CERTIFICATE OF APPROPRIATENESS

Property: 443 Columbia Street, Lot 2, Block 304, Houston Heights Neighborhood Subdivision. The property includes a historic 780 square foot, one-story wood single-family residence situated on a 6,600 square foot (50' x 132') interior lot. An addition of 851 sq. ft. was constructed in 1998 increasing the total square footage to 1,631 sq. ft.

Proposal: Alteration: Second-Story Addition

Recommendation: Denial - does not satisfy criteria
Design Guidelines

Proposed Second Floor Plan

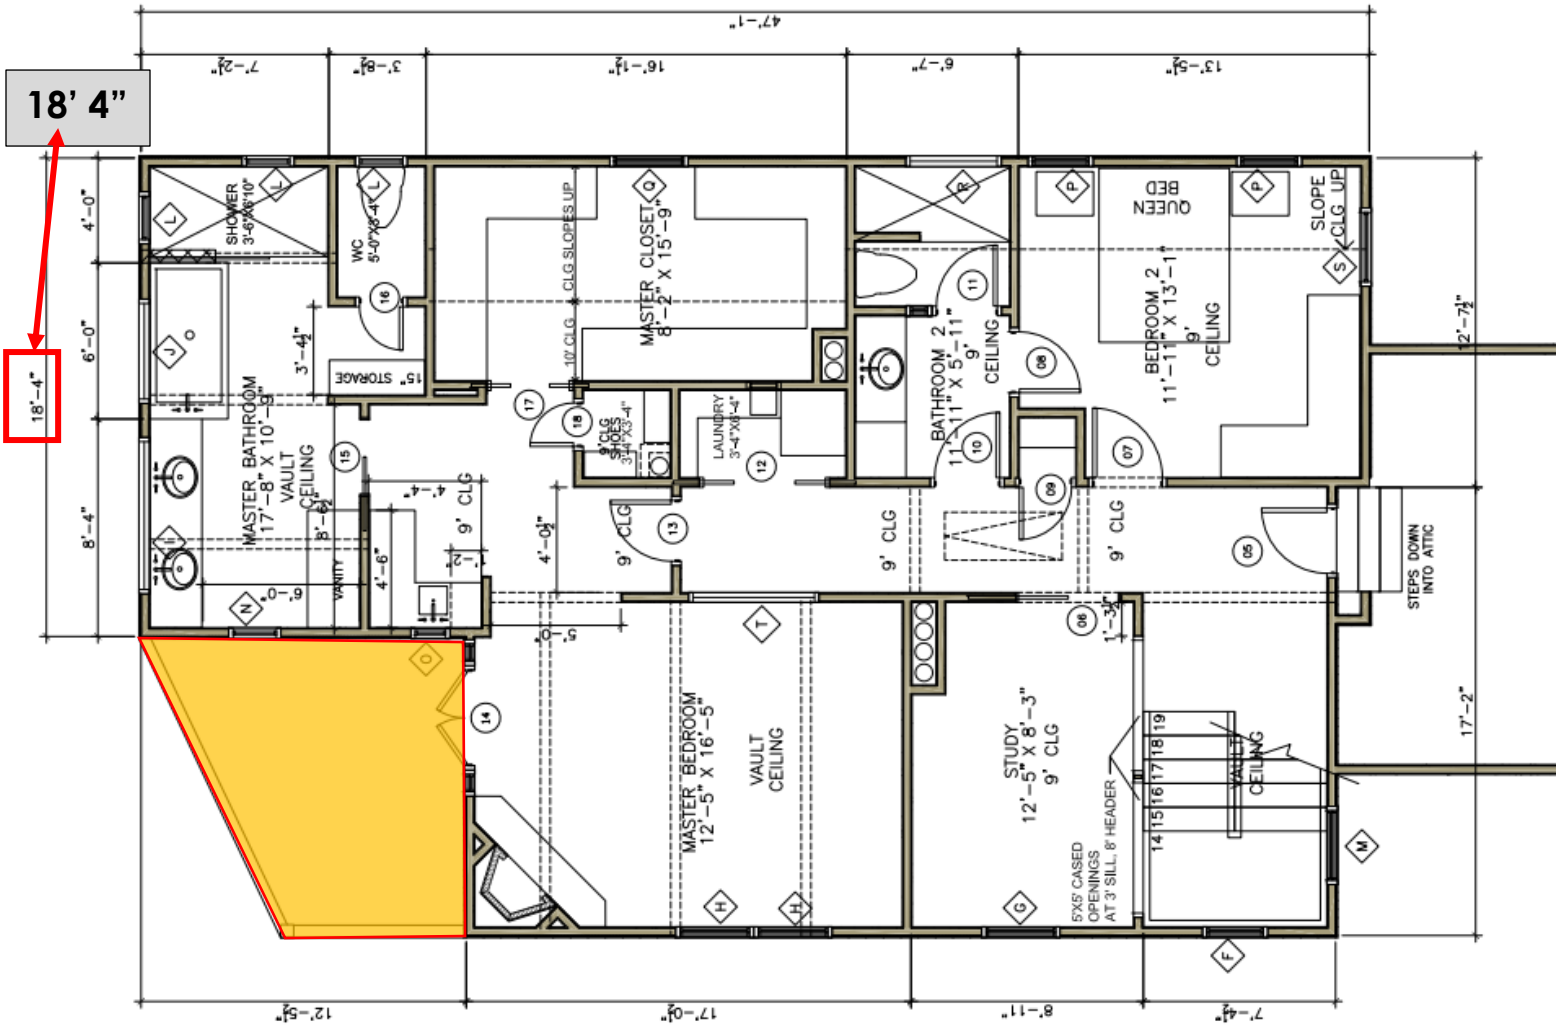
| <input type="checkbox"/> | <input checked="" type="checkbox"/> | <input type="checkbox"/> | In accordance with Sec. 33-276, the proposed activity must comply with the City Council approved Design Guidelines. Second-story conditioned space above porch space that is not a typical porch dimension and is incompatible with the qualitative standards set forth in the design guidelines. |

Area shaded in yellow is the second floor open balcony

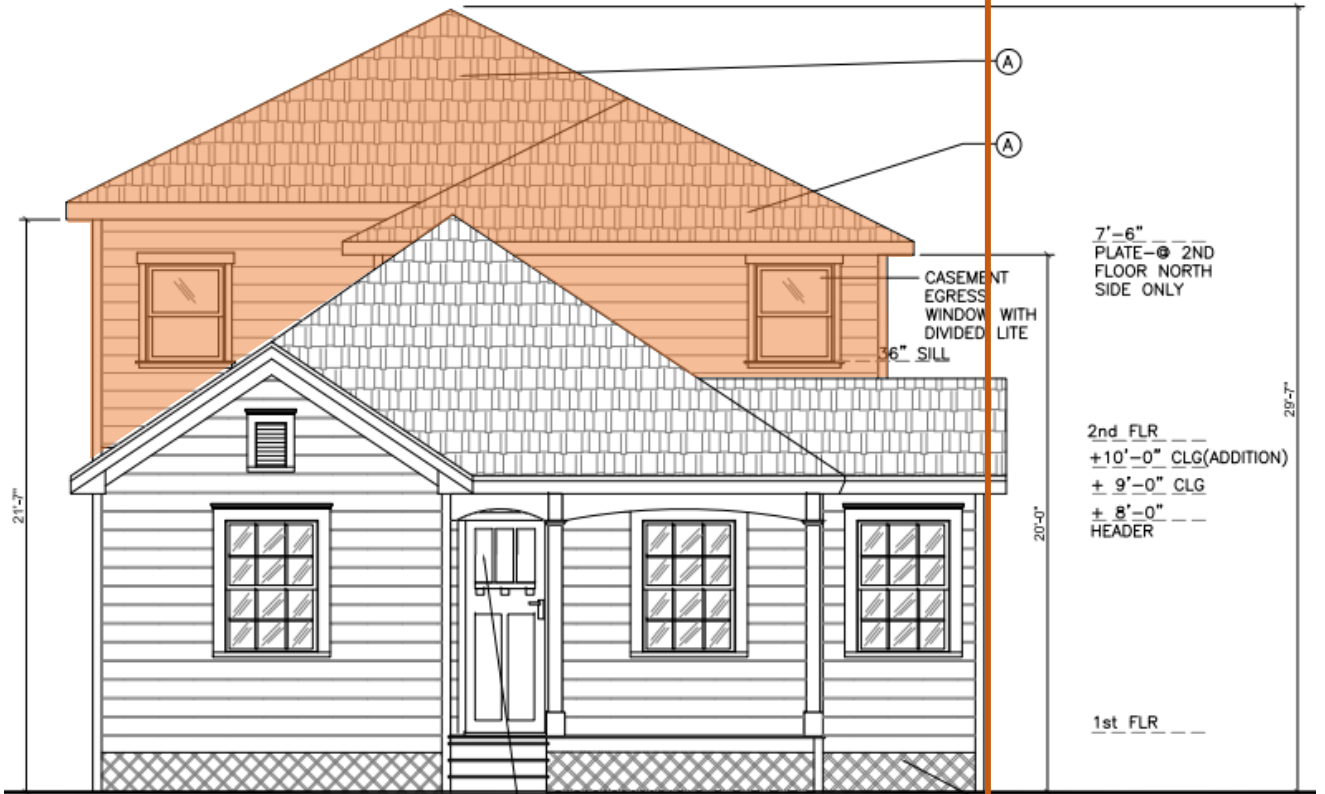
Area shaded in yellow is the second floor open balcony
